Drawing Title			
PROPOSED PLANS			
LOWER GROUND AND GROUND			
North	Drawn	RW	Date
			SEPTEMBER 2019
			Scale
			1:100
Filename			
Job No	Drawing No	Revision	
1908	DA02	B

KELLEHER RESIDENCE
12 MONTPELIER PLACE
MANLY

PROPOSED ELEVATIONS

Drawing title			
PROPOSED SECTIONS			
North			
		Drawn RW	
		Date SEPTEMBER 2019	
		Scale 1:100	
		Filename	
Job No	Drawing No	Revision	
1908	DA05	B

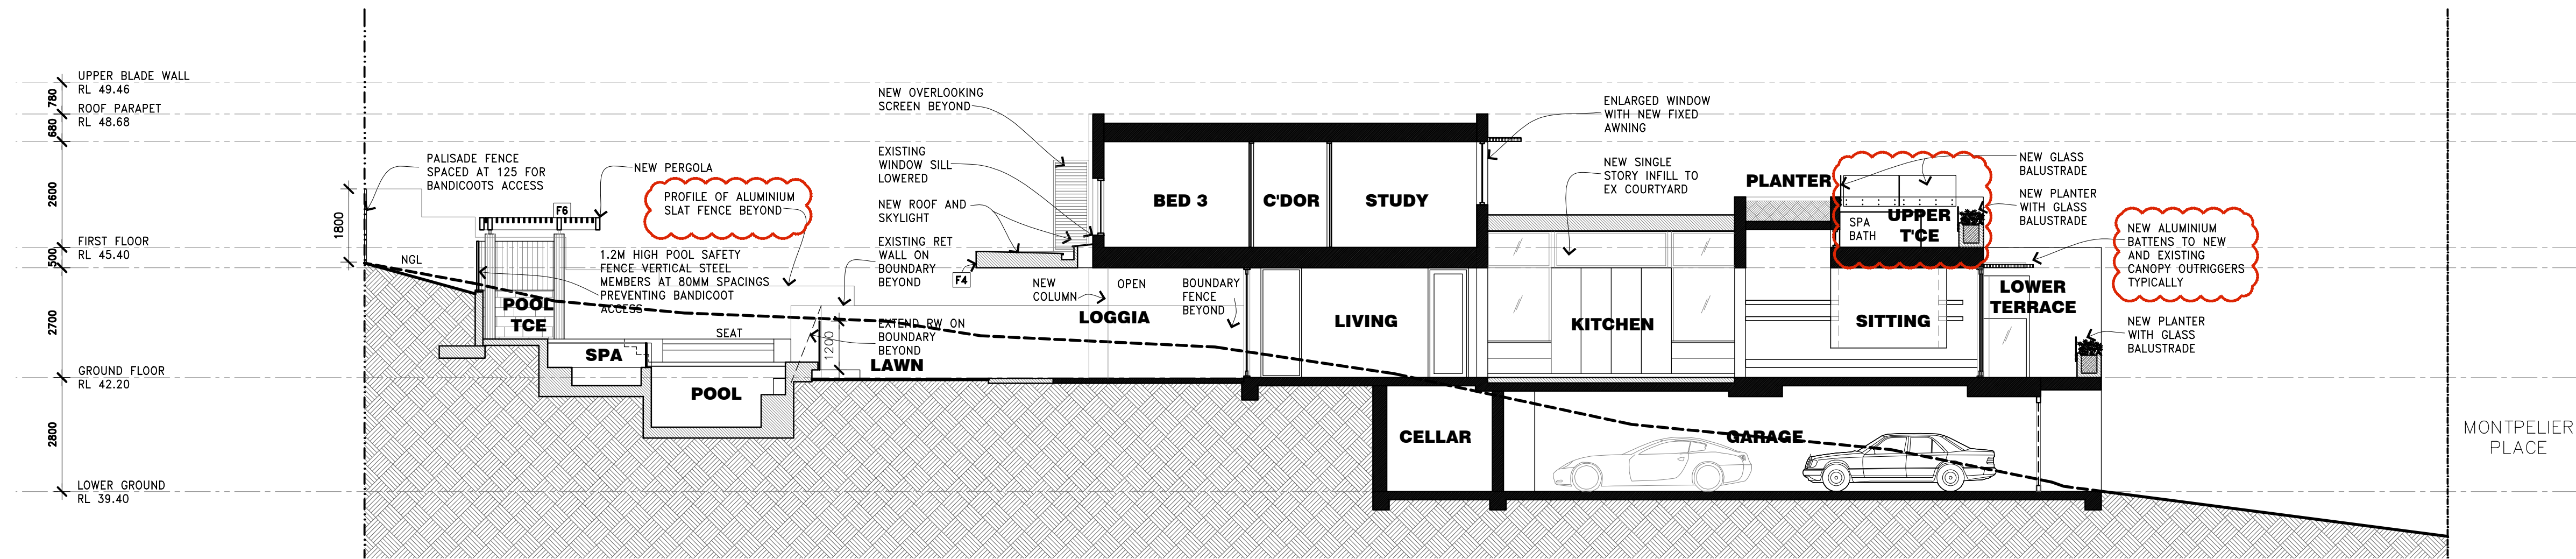
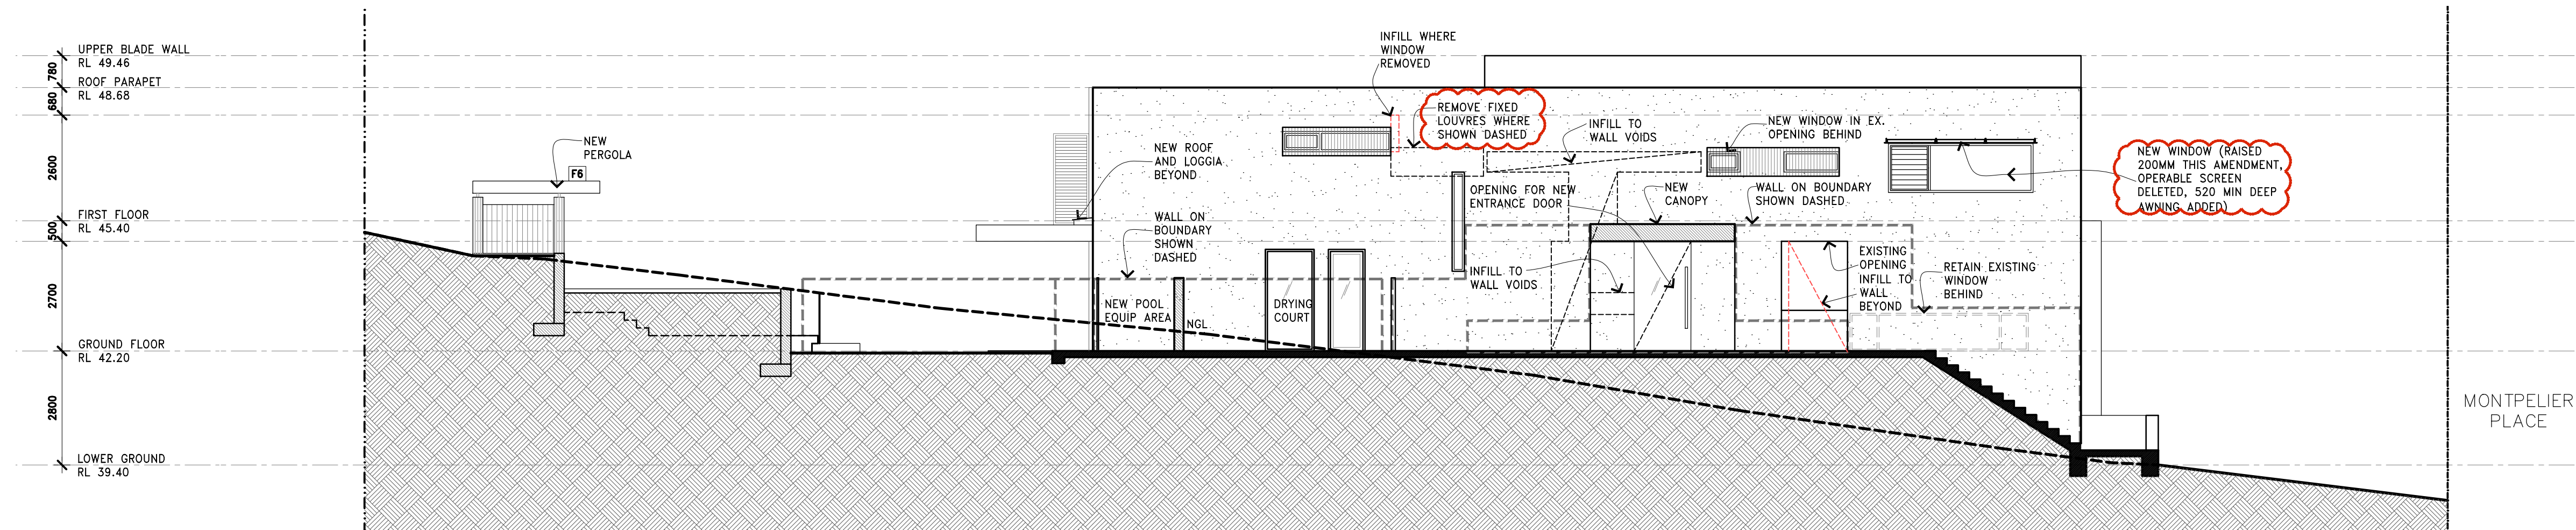
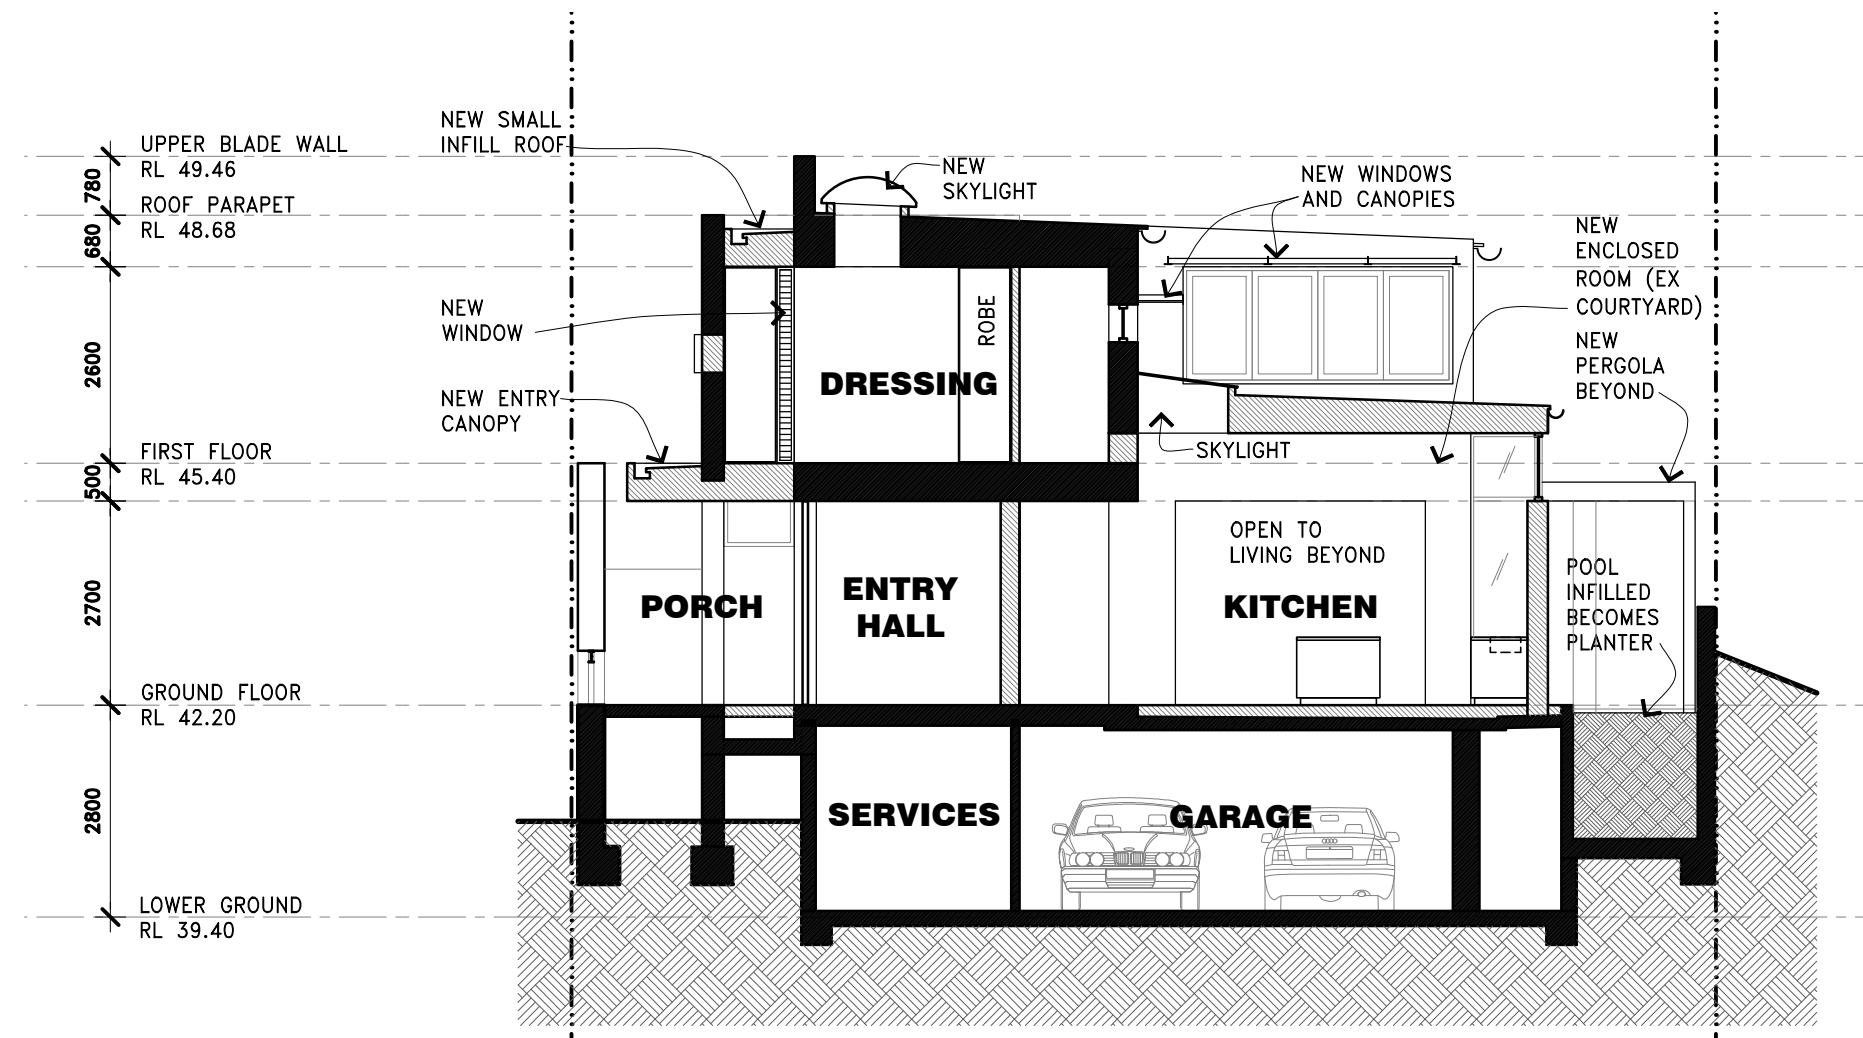
B RW 10/08/21	Basement- porches added Basement- RW tanks relocated Ground-kitchen walls changed, skylight increased Ground- east end added to Entry Ground- no roof or retractable awnings to west terrace Ground- pool retaining walls adjusted Ground- Games Rm door changed to sliding Upper- spa added to terrace, balustrades added Upper- Bed 1 window east raised 200mm, operable louvers deleted, awning added Upper- skylight added to stairwell Upper-corridor duct removed, no linen capd Upper-door to Bedroom 2 changed Upper- South Ensuite sill lowered 300mm Upper- Bed 2 window screen altered Upper- redundant louvers removed General- new and existing sunshade canopy detail changed to al. batten General- Weatherflex cladding changed to painted 30mm grooved panels General- boundary fences and retaining walls clarified, changed to aluminium and palisade where shown Plaster added to front edge of balconies Balcony added to front of master bedroom Window added to east elevation Window added to west elevation B80 relocated adj Breakfast Loggia /support for first floor S/W corner changed Fence added around pool terrace Pool and safety fencing redesign
